AMENDMENTS TO THE DRAWINGS:

REMARKS

Appl No. 09,779,790
Amdt. Dated Feb. 28, 2006
Reply to Office Action of December 28, 2005
Annotated Sheet Showing Changes

FIG. 2

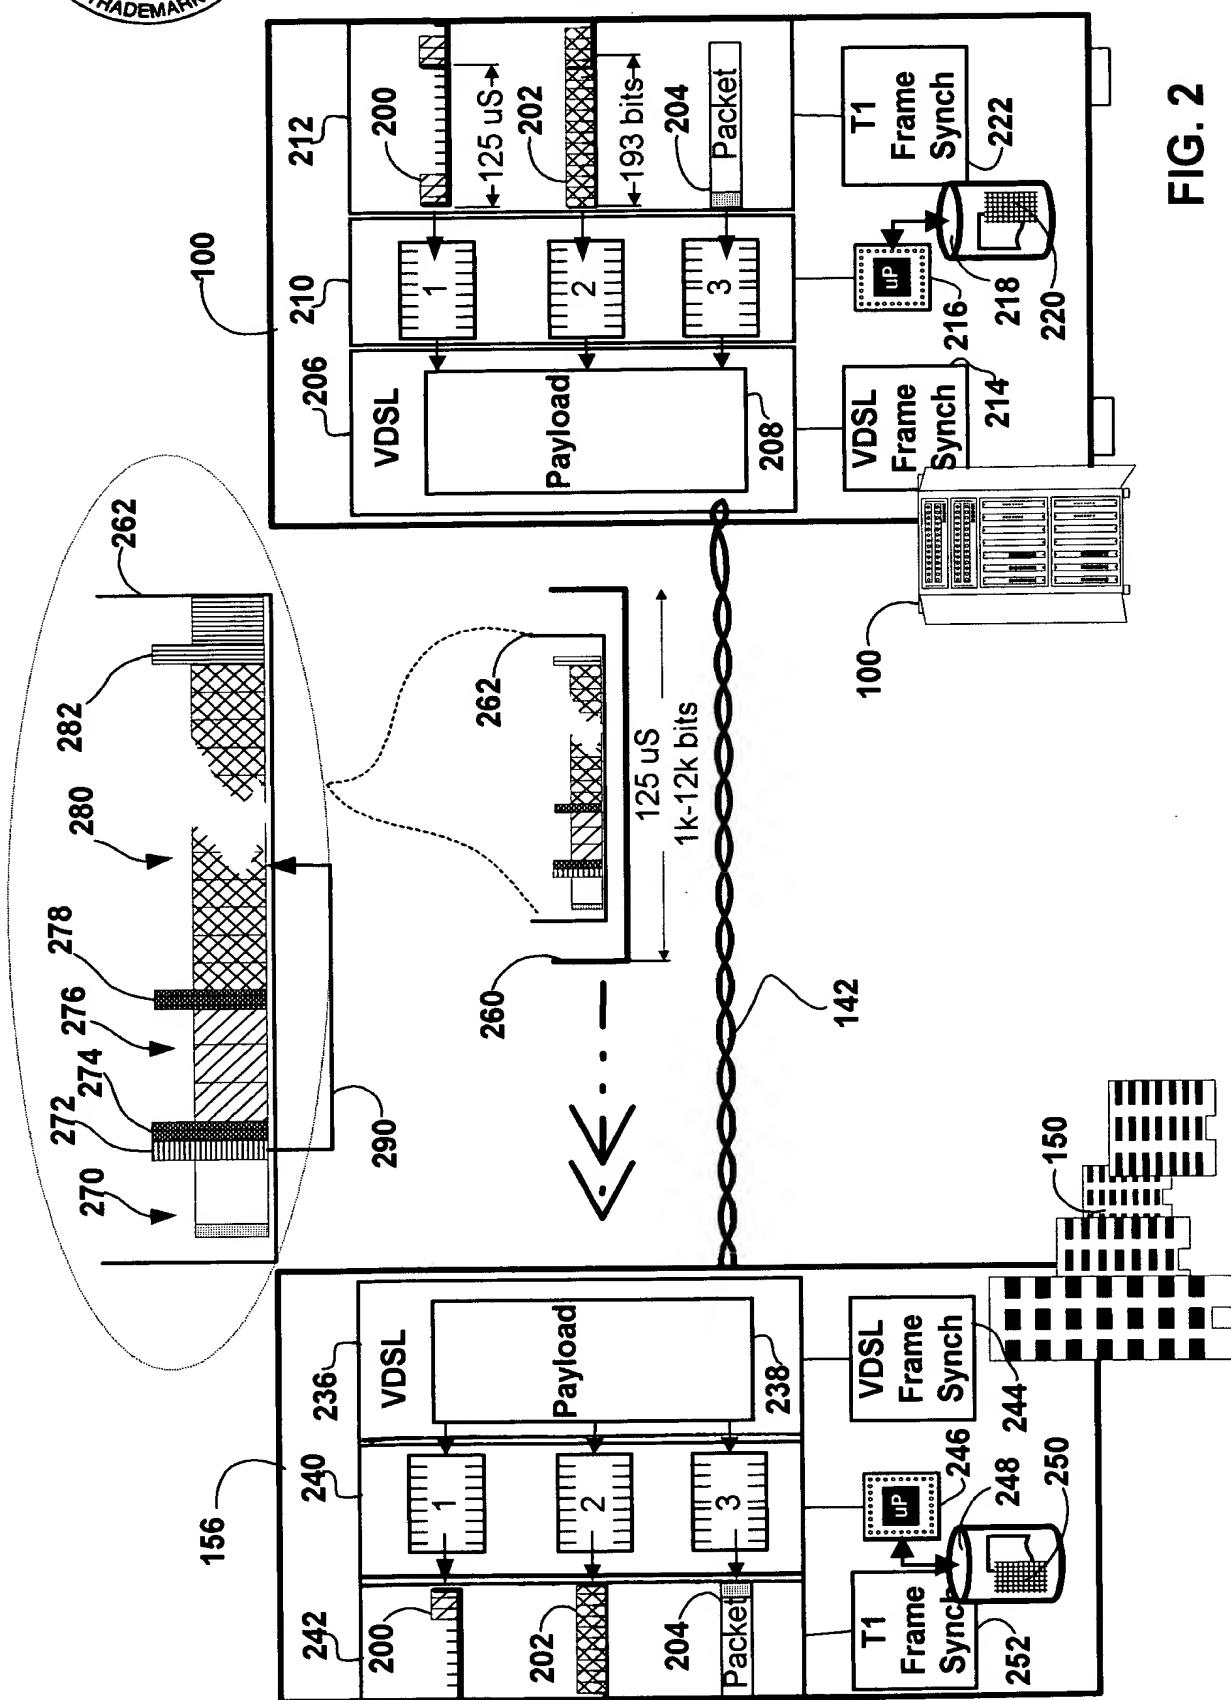
Figure 2 was objected to under 37 CFR 1.84(p)(4) because blocks 236, 240, 242 designated a common block.

Applicant has amended Figure 2 to show the separation of the adjacent vertical sides of the referenced blocks.
